HARTING Product Change Notification

Business Unit: Electric
Product range: Han / Han-Modular
Author: Heinz-Guenter Spreen
Title: Han Quintax Module - External

PCN/20/002/C+N
Date: 2020-02-05

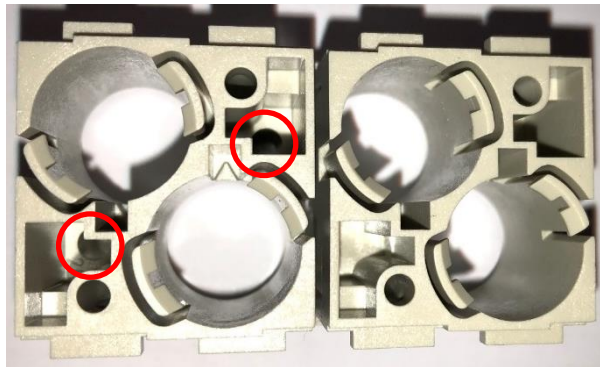
The Han Quintax Female Modules and Han HV Female Modules 16A and 40A will get additional holes in the deepening on the termination side.
 At the Han HV Female Modules it is invisible as the metal fixing plate covers the termination side.
